Technical Service Bulletin

Subject: A CREAKING NOISE OCCURS NEAR THE DOOR WHILE DRIVING	Bulletin No.: 09-021/25
	Last Issued : 04/23/2025

2024-2025 CX-90
2025 CX-70

Adjust the staple position of the striker

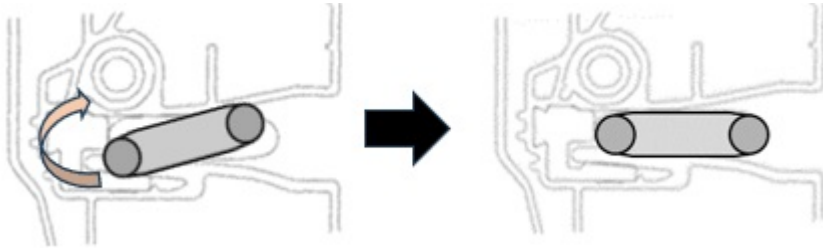
To measure the tilt, place the scale horizontally

- (1) Inner side
- (2) Outer side
- (3) Scale
- (4) Staple

Adjust the angle of the striker horizontally. (Refer to Adjust Door Lock Striker section in (Door Lock Striker Removal/Installation) in MGSS.
